COMMUNITY DEVELOPMENT DEPARTMENT REPORT

SUBJECT: TECC-2025-0001
Pura Vida Ranch Subdivision – TECC

LOCATION: 3727 E. Lake Hazel Rd., in the NW 1/4 of Section 4, T.2N., R.1E.

C. Approved Landscape Plan (dated: 10/12/20)

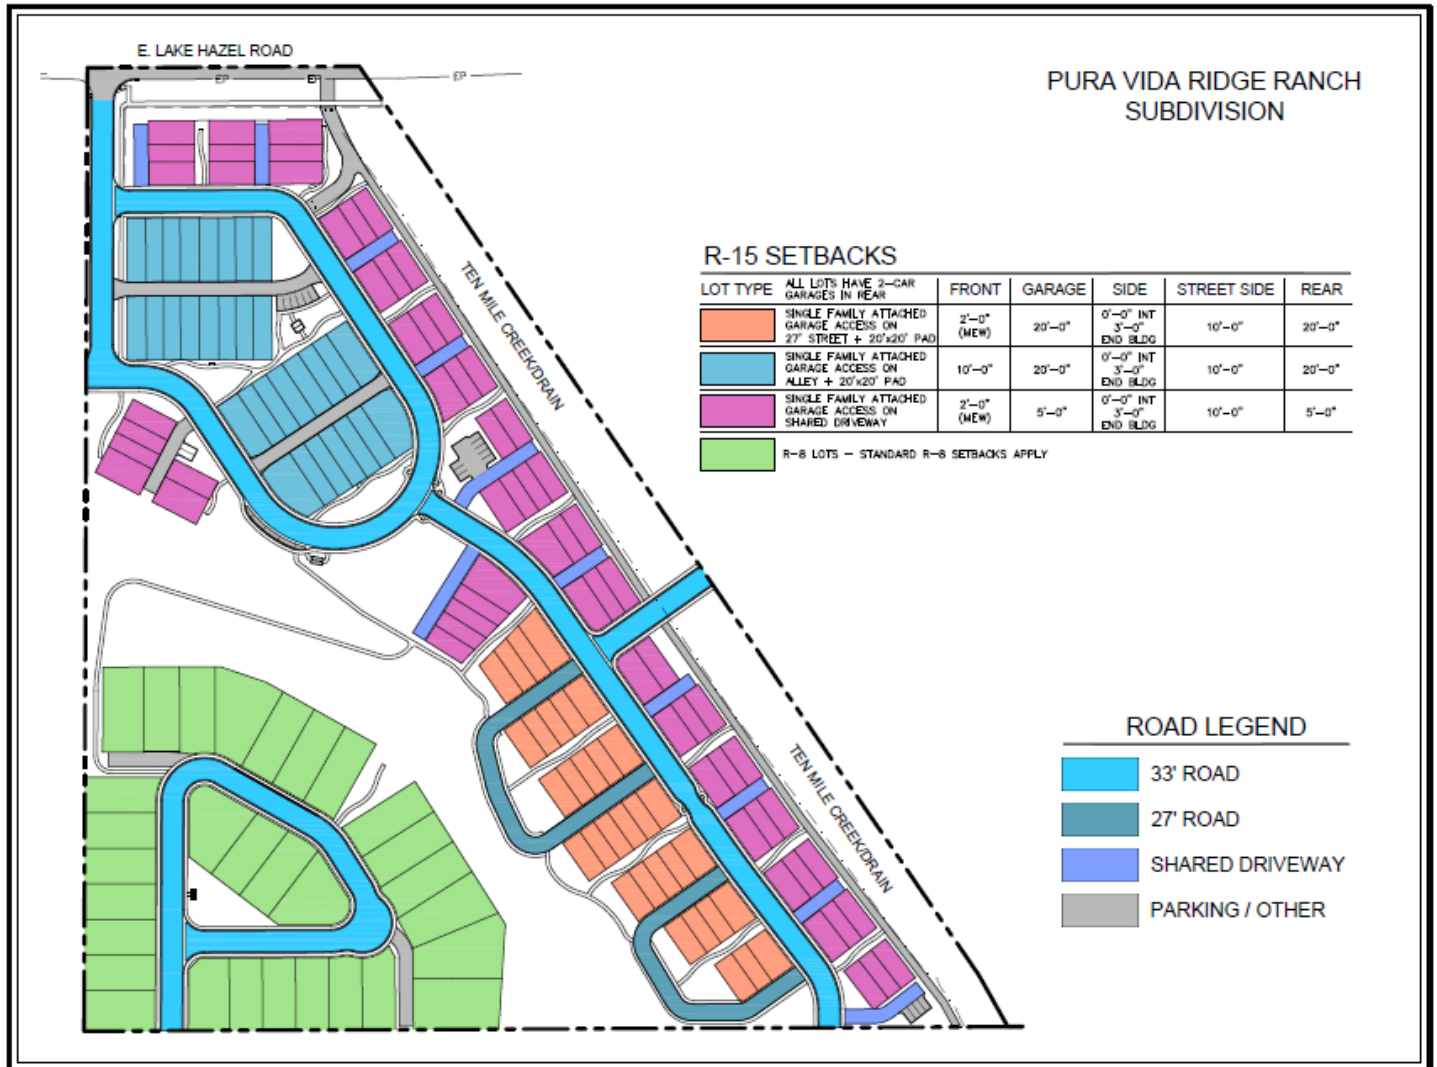
- A 7-foot wide detached sidewalk was approved within the street buffer along E. Lake Hazel Rd. A 10-foot wide detached sidewalk is currently required.

As a conditions of the subject time extension, Staff recommends a 10-foot wide detached sidewalk is provided in lieu of a 7-foot wide sidewalk along E. Lake Hazel Rd.; and vegetation on the hillside is maintained regularly to prevent a fire hazard.

1. Applicant shall comply with all terms of the annexation and zoning (Development Agreement Inst. #2021-042520), preliminary plat, planned unit development (H-2020-0064), final plat (FP-2021-0043), final plat modification (MFP-2022-0001) and previous time extension (TED-2022-0009).
2. A ten (10) foot wide detached sidewalk shall be constructed along E. Lake Hazel Rd.
3. The vegetation on the hillside shall be maintained regularly to prevent a fire hazard.
4. The Applicant shall commence the permitted use and obtain the City Engineer's signature on the first phase final plat on or before January 19, 2027; or, apply for a time extension prior to that date as set forth in UDC 11-5B-6F and 11-6B-7, in order for the planned unit development and preliminary plat to remain valid.
